Ollerton Roundabout

Road Safety Audit Stage 1 - Completion of Preliminary Design

SA2166A
March 2018

Location: 3.1 – Ollerton Roundabout.

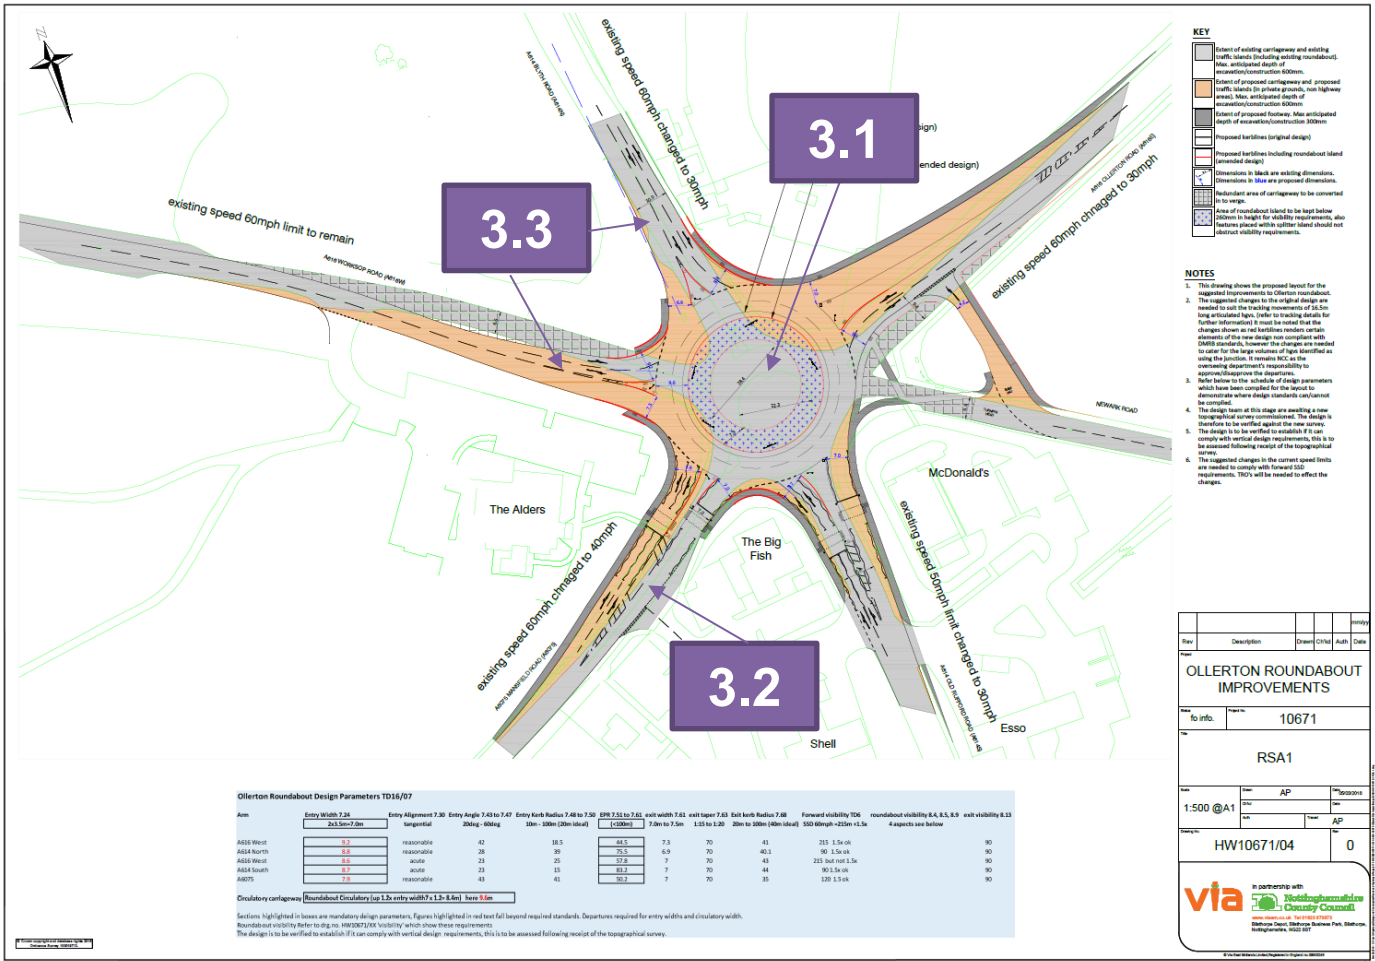
Summary: Increased number of entry and circulating lanes leading to an increase in conflicts and vehicular collisions.

Increasing the number of entry lanes and circulating lanes will lead to an increase in conflicts and an increase in collisions. The arms of the roundabout are very close to each other and drivers will have to make decisions very quickly about whether to enter the roundabout or not, while considering the movements of vehicles in two lanes of circulatory carriageway and 2 entry lanes. Entry versus circulating accidents are likely to occur, resulting in injury to vehicle occupants.

The current roundabout has a very good accident record considering the volume of traffic that uses it, these proposals are highly likely to worsen this record.

Enlarge the roundabout.

Problem No. 3.1
Designer input	The scheme is promoted on capacity requirements, although it would be ideal to provide a roundabout larger than currently proposed this is not feasible at the current junction location due to land constraints. Whilst it is understood the junction has a very low accident history a do something scenario is needed here. To fully meet with design standards an alternative form of junction or a larger roundabout would need to be provided this would prove prohibitive due costs of either acquiring additional private land/buildings or relocating the junction away from its current location. Also see recommendation provided by Simon Taylor in response to the departures form standards request.
Client Input	Agree with designer's response.
Action	Progress current scheme
Approx. Cost of recommendation	No additional cost

Summary: Collisions between vehicles exiting The Big Fish and vehicles on the A6075

Collisions at the junction with The Big Fish may increase as there are now 2 lanes approaching the roundabout and a 2 to 1 lane merge on the exit from the roundabout.

Drivers turning right from The Big Fish will have to negotiate all these lanes, and may emerge into the path of an oncoming vehicle. Collisions could occur, resulting in injury to vehicle occupants.

Vehicles exiting the roundabout may be travelling fast, to get ahead of another vehicle at the merge. If a driver exiting the Big Fish pulled out into the path of a vehicle travelling at speed vehicle occupants may be seriously injured.

Alter the access arrangements to The Big Fish to prevent vehicles emerging from this access. The internal layout could be altered to allow vehicles to use the access on the A614.

Problem No. 3.2
Designer input	Proposals are currently being considered to remove egress from the current location (entry permitted) and amending egress arrangements through the petrol station exit on to the A614. Client and PM to initiate negotiations with current property owners.
Client Input	In the event that the negotiations with adjoining landowners prove fruitless then consideration should be given to either relocating the Big Fish access / egress to the western boundary of the sites frontage to A6075 where there are fewer lanes for vehicles to cross/join, or provide a separate egress (left out only) from the property to the A614 on the limited frontage the site has with the A614. This would then allow all movements to be left in and left out and remove the safety issues associated with right turning traffic.
Action	Enter negotiations with property owners
Approx. Cost of recommendation	Currently precise cost not known, but estimate circa £50,000 construction costs

Summary: Head on collisions due to lack of physical separation.

There is no physical separation between opposing lanes. Vehicles exiting the roundabout, that merge late, may cross into the opposing carriageway and collide head on with opposing vehicles, resulting in injury to vehicle occupants.

Lengthen the proposed splitter islands or provide small satellite islands.

Problem No. 3.3
Designer input	Recommendation incorporated in current design layout dgr.no. HW 10671/06 rev A
Client Input	Recommendation already taken on board
Action	N/A
